## BID PACKAGE #2 ADDENDUM #01

**DATE:** December 5, 2024      **PROJECT NO:** 24-038  
**TO:** Gramoll Construction      **PROJECT:** DTC Welding Technology Bldg  
155 S 750 W St  
North Salt Lake, Utah 84054

The original specifications and drawings, labeled “Bid Package #2”, dated November 1, 2024 and issued for the project referenced above are amended by the following content and form a part of the Contract Documents.

ARCHITECTURAL  
SITE PLAN  
**AS101.2**

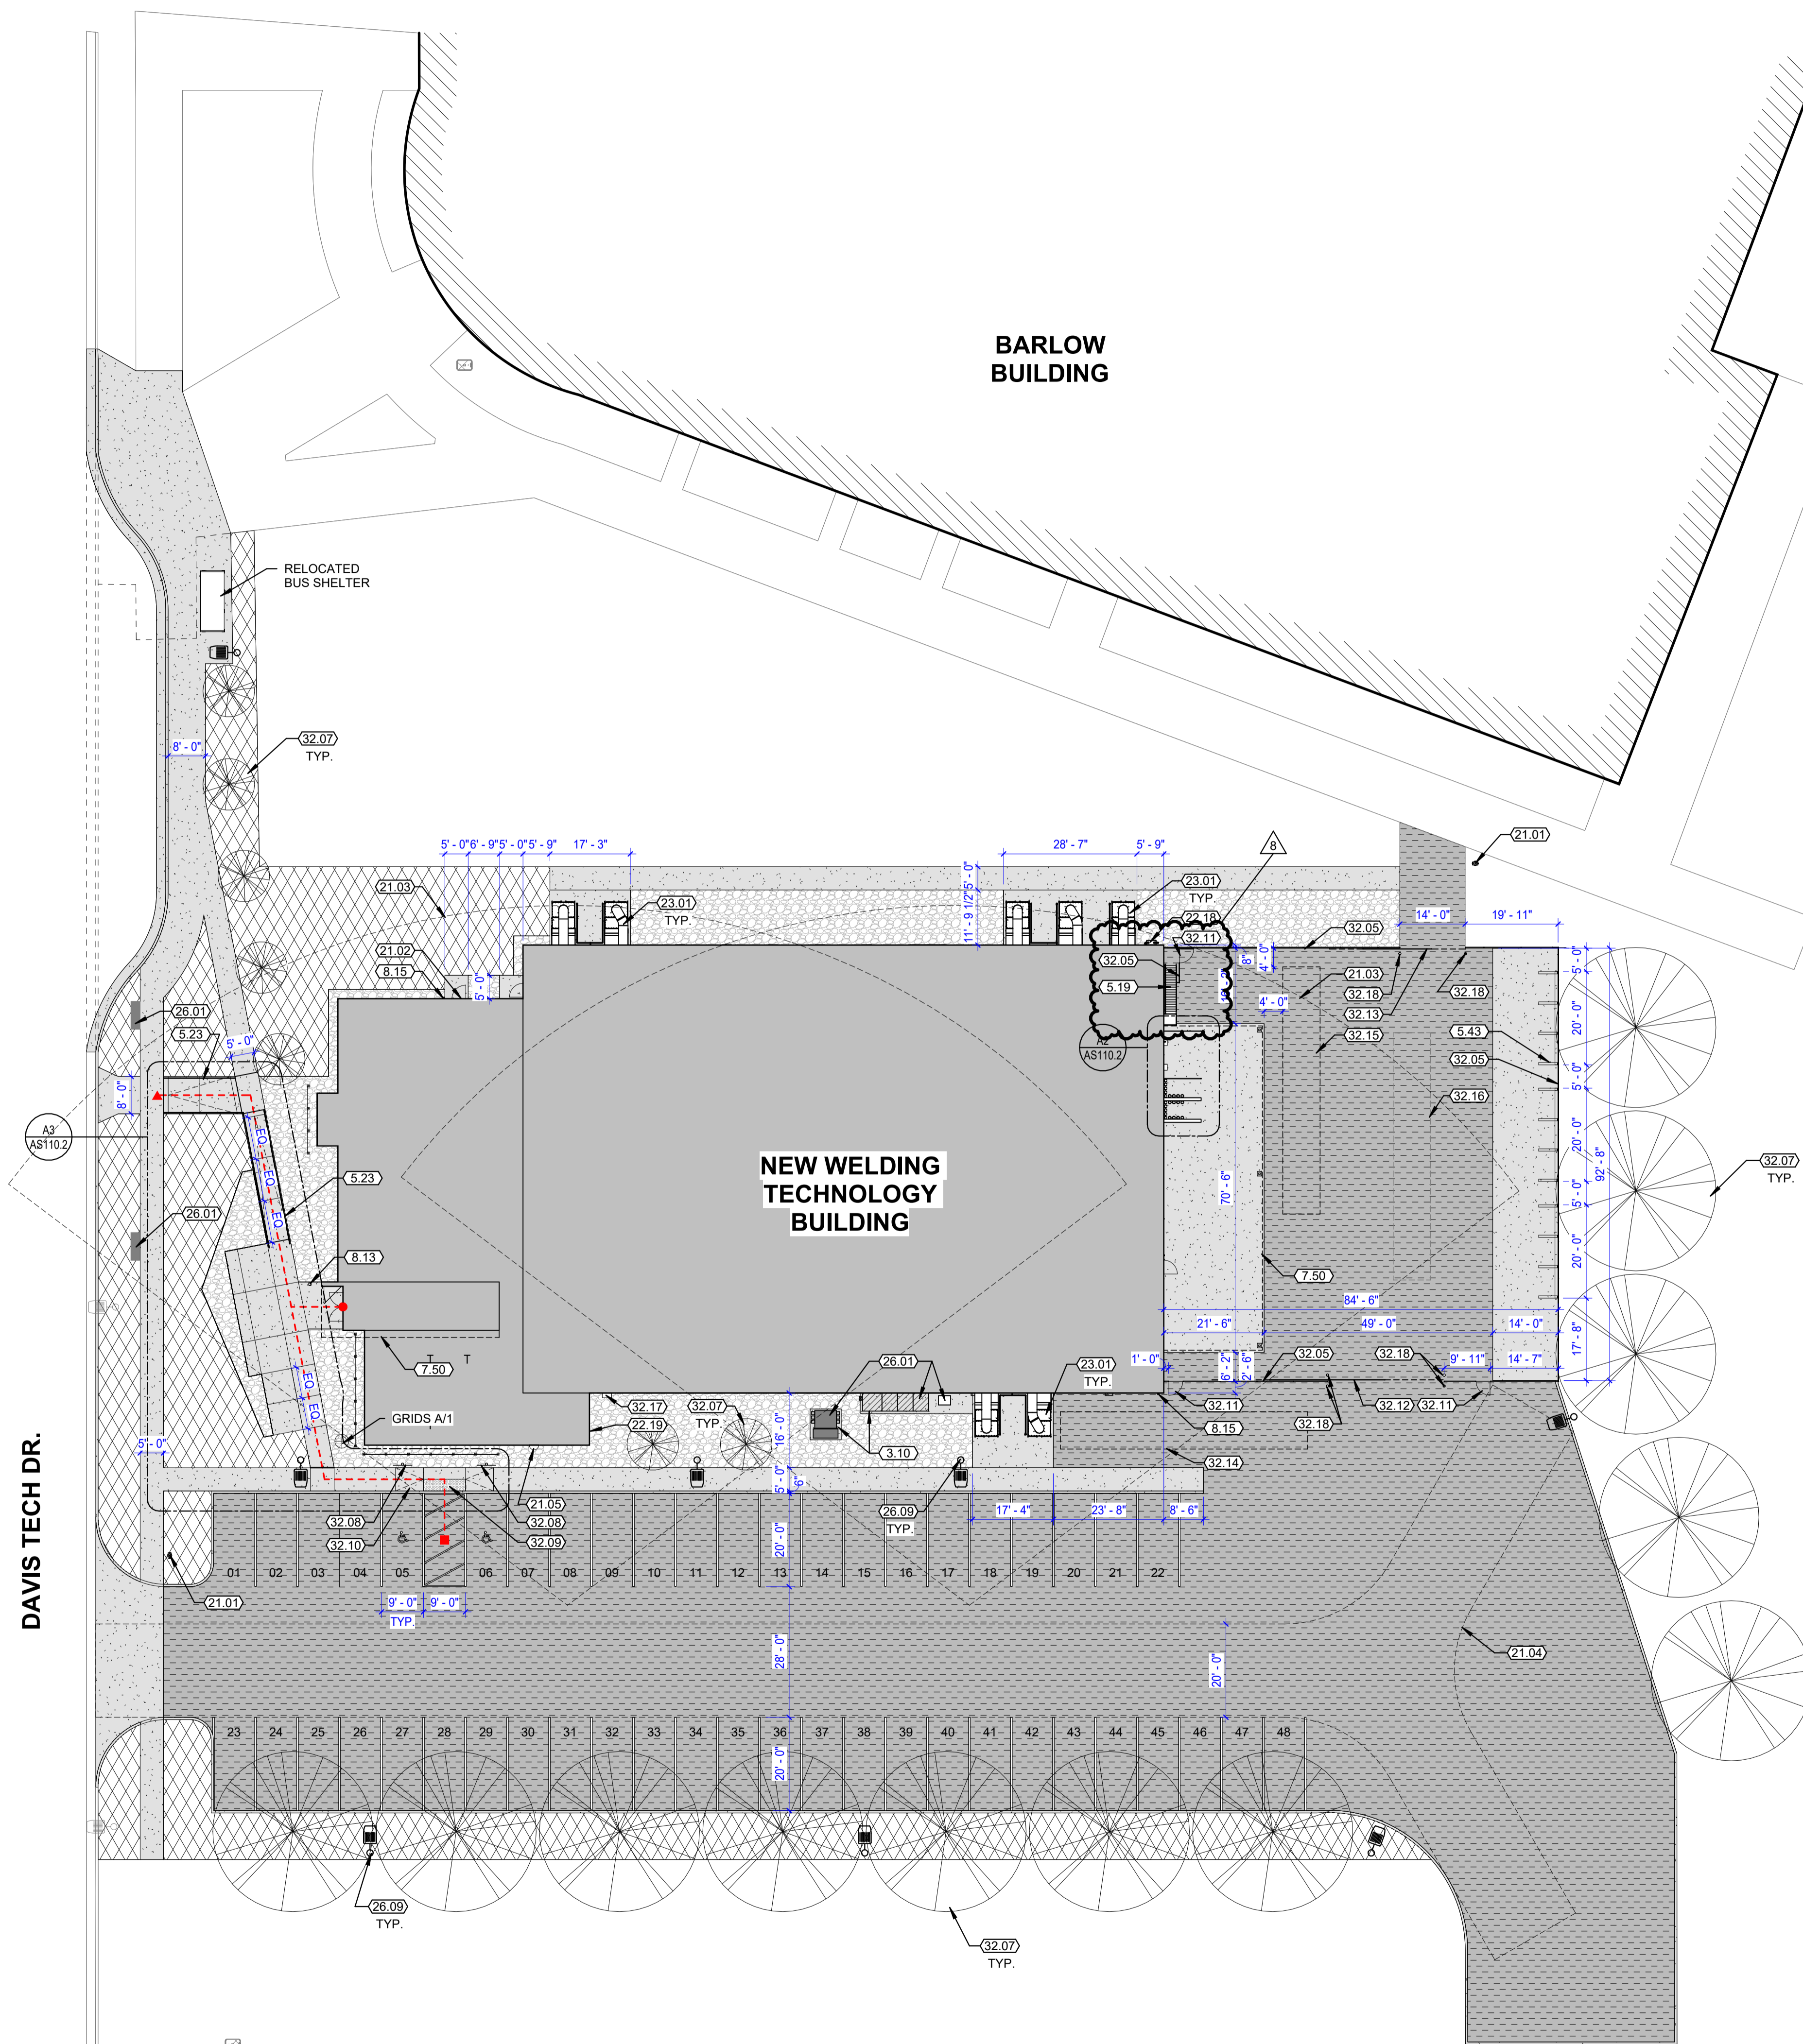
1. Q: Please confirm height of chainlink fence.  
A: *Chainlink fence and gate heights are 72”H. Please see attached drawing revisions.*
2. Q: On the floor finish plans in one place it says densified concrete and in another place it says FC1 is polished concrete. Can you confirm which one is correct?  
A: *Densified concrete is correct. Please see attached drawing revisions.*
3. Q: Roofing substitution request.  
A: *Approved as noted. See attached form.*
4. Q: MCM Panel substitution request.  
A: *Approved as noted. See attached form.*

- a. AS101.2
  - i. Revised drawings to show new ships ladder location, chainlink fence & gate.
- b. AS110.2
  - i. Added trench drain across lower end of sidewalk slope at entry plaza.
- c. AE101.2
  - i. Revised ships ladder location.
- d. AE151.2
  - i. Added alternate base material for Base Finish BS1. Bidders to provide alternate pricing for this material.
- e. AE191.2
  - i. Revised ships ladder location & deleted roof hatch.
- f. AE201.2
  - i. Revised exterior elevations to show new ships ladder location & chainlink fence.
- g. AE402.2
  - i. Revised interior elevations to show revised student refresh millwork.
- h. AE525.2
  - i. Revised ships ladder details.
- i. AE530.2
  - i. Revised student refresh millwork elevation to add cabinets. Deleted countertop bracing detail.
